CONDITIONAL APPROVAL
PLAN APPROVAL EXPIRES: 01/06/2018

Mccains Foods
Hwy 54 & 110TH St
Town of Plover, 54467
Portage County

Facility: 743440 MCCAINS FOODS
HWY 54 & 110TH ST
PLOVER 54467
Plan Type: Addition-Alteration; 1 Interior Fixture(s)

Object Type: Commercial Water Treatment Device Regulated Object ID No.: 1575788

DWG. TITLE: Drinking Water Station &
 Sample Site Locations 1st Floor (South)

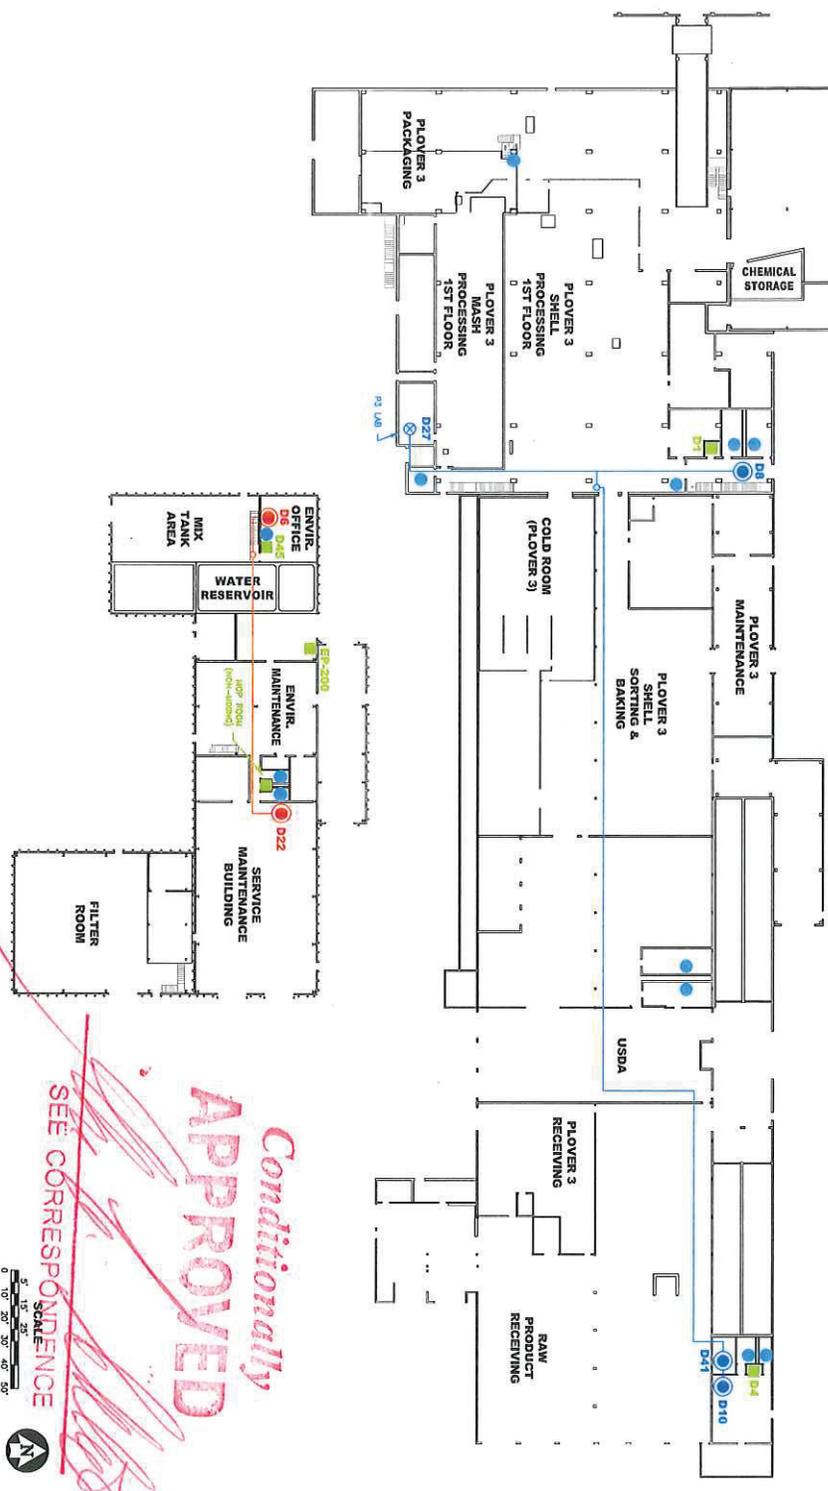
Item numbers 4 and 5 are installed under the breakroom sinks within the Americold annex and do not serve any coolers.
